Development Permit Panel

Wednesday, September 27, 2017
3:30 p.m.

1. **DEVELOPMENT PERMIT 16-726865**
(REDMS No. 5510231)

2. **DEVELOPMENT PERMIT 16-735007**
(REDMS No. 5493885)

WEST ELEVATION
SCALE: 1"=10'-0"

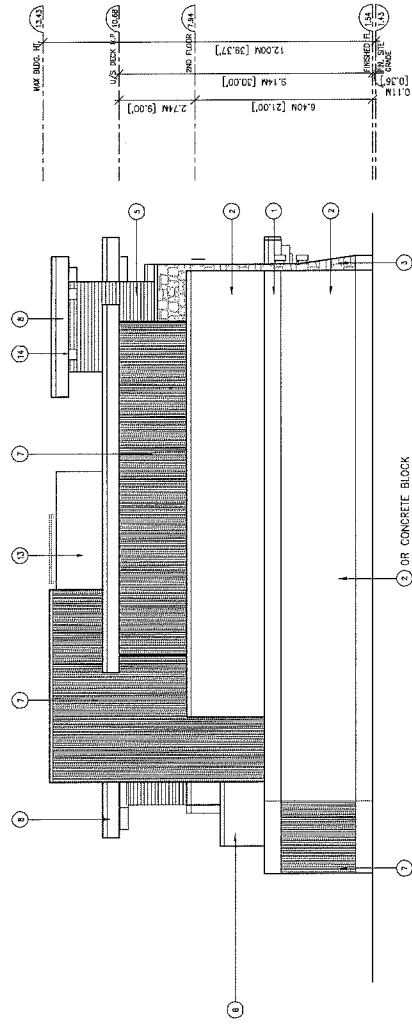
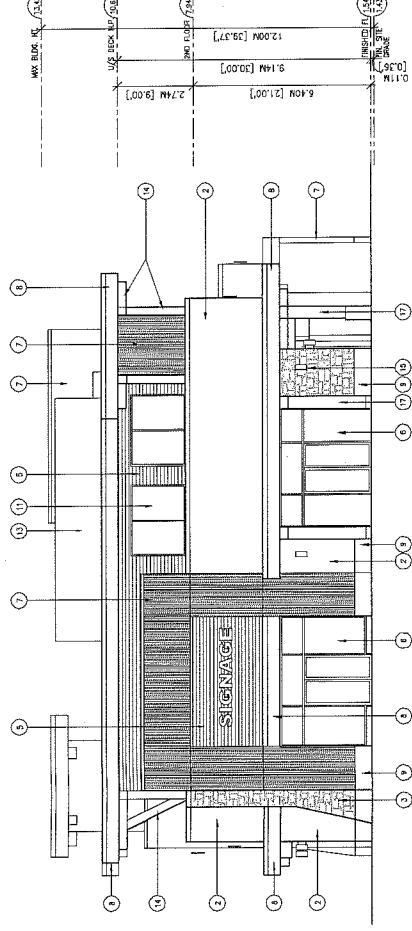
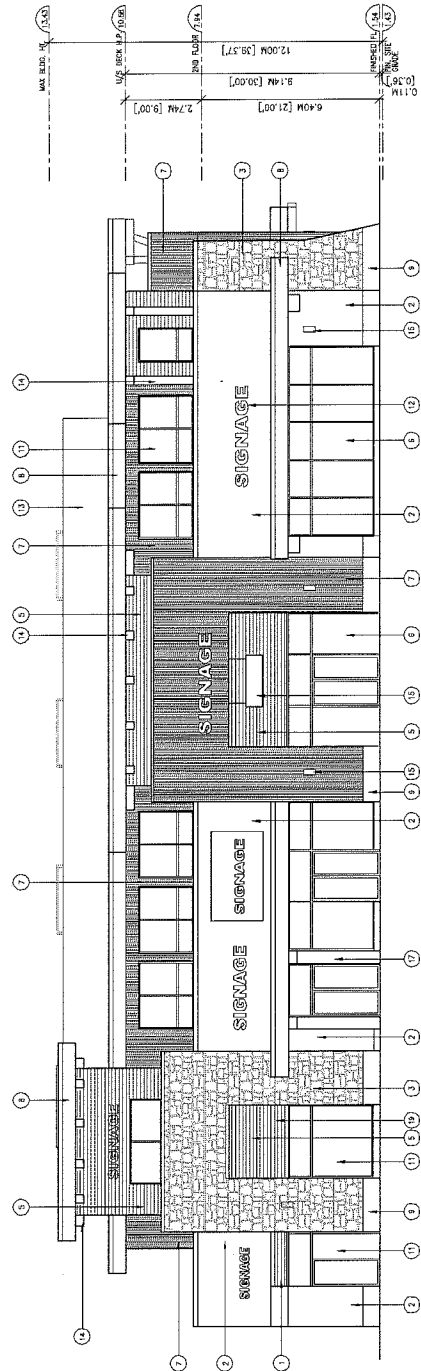
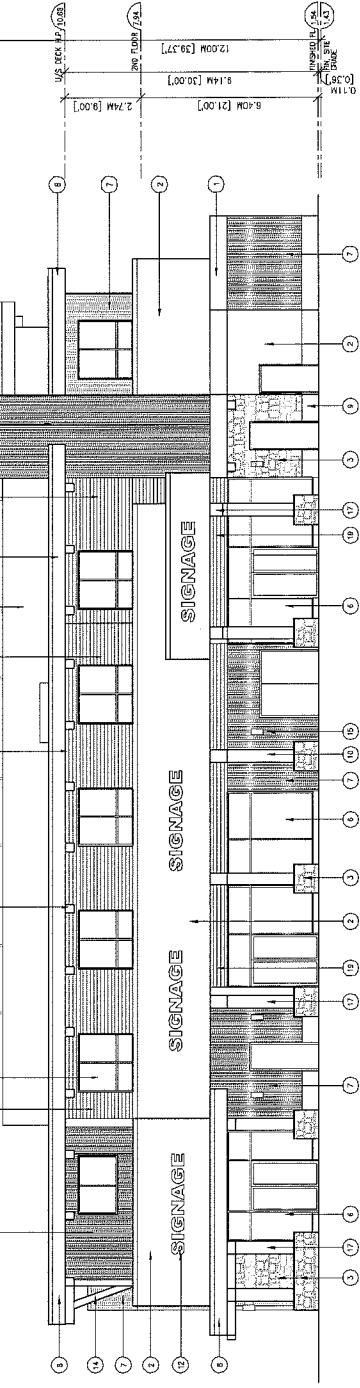
- there is too much articulation and variation in commercial edge expression for a modest-sized building; intent to provide visual interest through variation in materials and colour resulted in over articulation of the building; the massing of a two-storey building is fairly compact and final massing could be achieved through a simpler form and lesser variation and contrast in materials and colour – *Revised. One coloured material combination removed to reduce the variation and contrast in materials and colour. The remaining degree of variation and complexity is intended for character and style purposes.*

- yellow-painted stucco will pose potential long-term maintenance concerns as the yellow colour tends to fade in the long-term and may collect street pollutants; consider an alternate colour/cladding material that is easier to maintain – **Revised. Changed to more neutral colour.**

ROOFTOP SCREENING DETAIL
SCALE: 3/4"=1'-0"

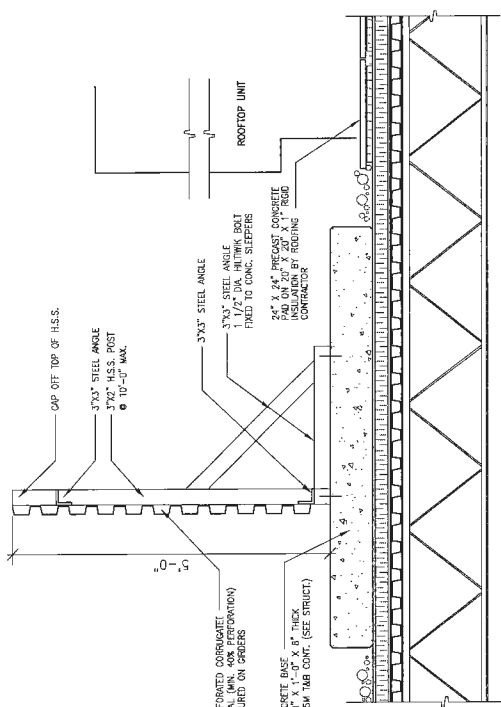
- support the installation of ballast on the rooftop; also support the installation of a larger continuous trellis for screening rooftop mechanical units in lieu of smaller individual trellises to minimize cost and provide a cleaner look – ***Considered. Individual overhead grille screening is proposed to minimize apparent massing of building and to facilitate future maintenance;***

Drawing Title:
SIGNAGE
ELEVATIONS

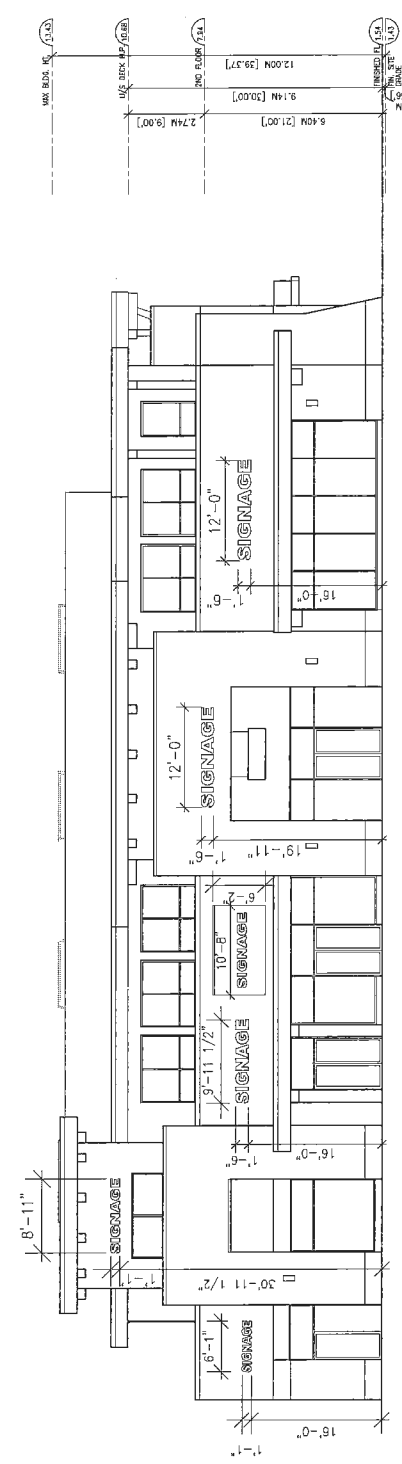
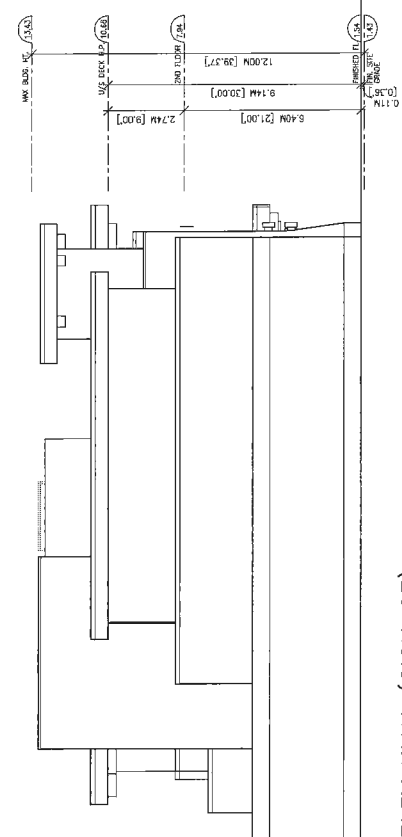
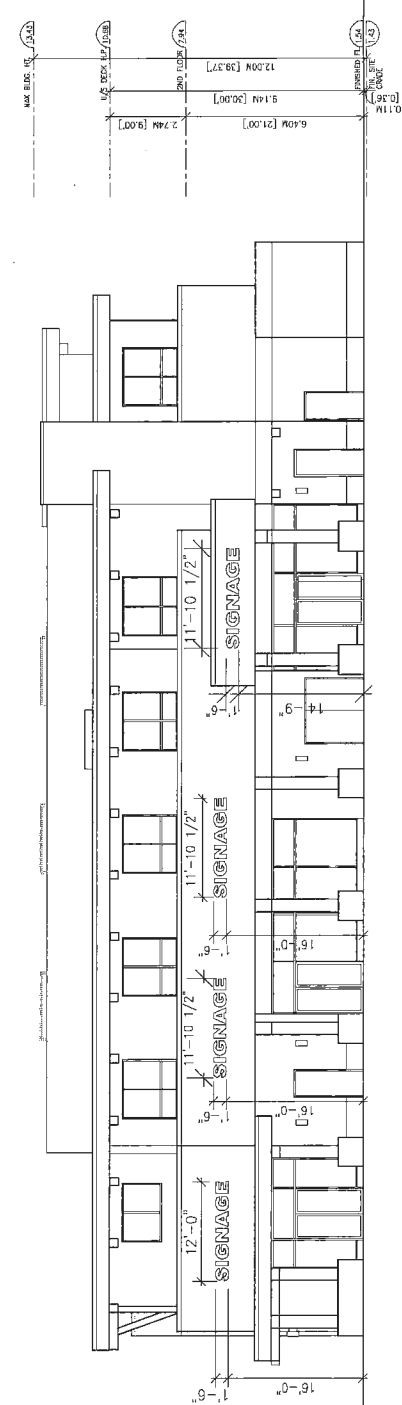
- proposed signage lacks a concept and appears arbitrary; signage could be more integrated into the building; too much flexibility for tenants in terms of determining location and style of signage could be problematic – **Revised. Signage height, elevation and type coordinated. Commercial signage is considered as important and constructive element for exterior design, where variation is preferred to achieve a more lively commercial atmosphere. Signage is proposed above entry doors to CRUs and office lobby;**

- applicant needs to develop signage guidelines to provide guidance to future tenants of the building; signage guidelines should be reviewed by City staff – **Addressed above;**

SKETCH PLAN SHOWING AREA OF PROPOSED COVENANT OVER ENVIRONMENTALLY SENSITIVE AREA ON LOT "B", BLOCK 64, SECTION 11, BLOCK 4 NORTH, RANGE 6 WEST, GROUP ONE, NEW WESTMINSTER DISTRICT, PLAN 1228

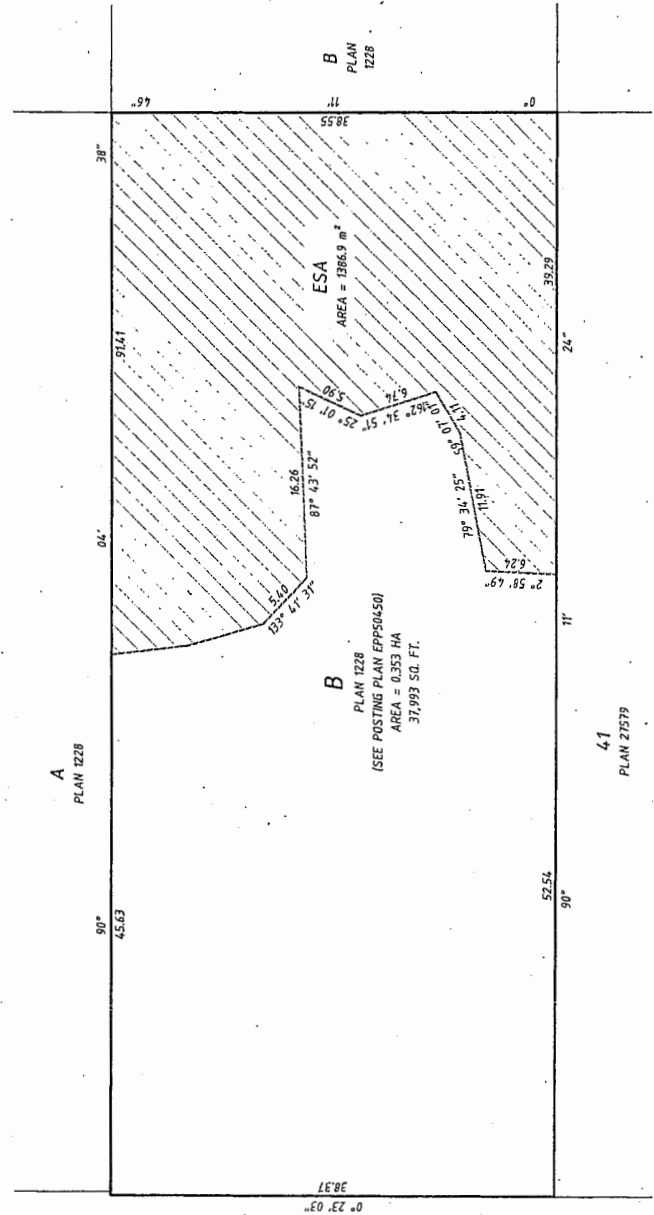
Panel Comment: ***Review and reconcile data provided by staff and the applicant regarding the extent of the proposed development's impacts to the ESA.***

Response: The site plan has been significantly modified by reducing the size of the house and increasing the area proposed to be planted and retained as ESA. The estimated area of the retained and enhanced ESA is approximately 1,934.5 m² (20,822.41 ft.²). This is an increase of the ESA of approximately 547.6 m² (5,894 ft.²) from the original application submission. The Development Permit Considerations include a requirement for submission of a sketch plan prepared by a surveyor which will be used to prepare a protective covenant for the ESA areas on the subject site.

SITE GRADING PLAN 1/16" = 1'-0"

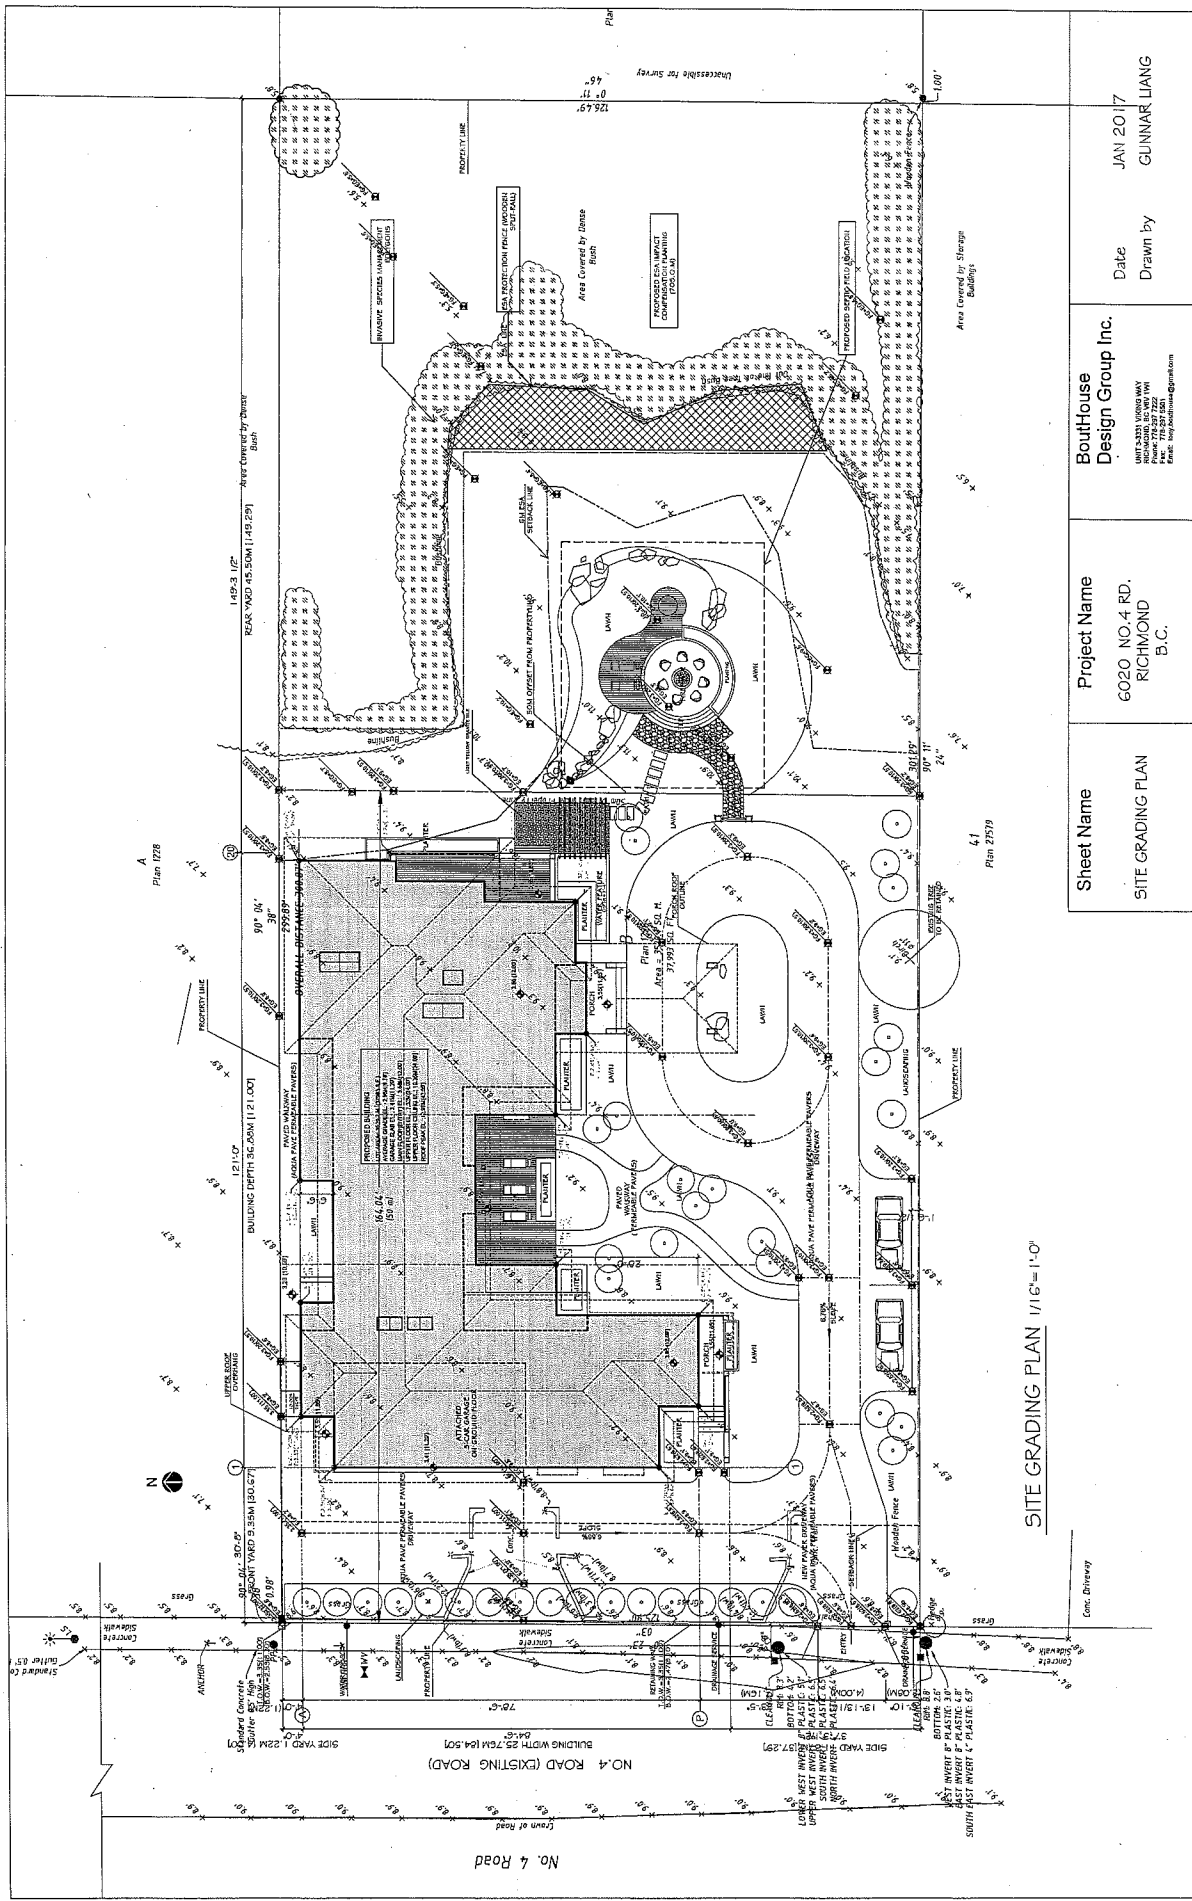
Panel Comment: ***Investigate and address potential impacts of the proposed development to neighbouring properties' drainage.***

Response: An updated grading plan has been submitted showing transitions to the adjacent properties. The grade differences are confined to the western portion of the lot with no grade changes at the rear of the property where the ESA is to be retained. Along the south side of the house the previous driveway will be replaced with native landscaping, allowing more infiltration into the soil. In addition, perimeter drainage will be required as part of the Building Permit application requirements. Perimeter drainage is required around the area being filled – in this case, at the western portion of the site where the house is proposed to be located. This combination of increased ground infiltration and perimeter drainage represent reasonable measures to address the majority of the storm run-off concerns from the site.
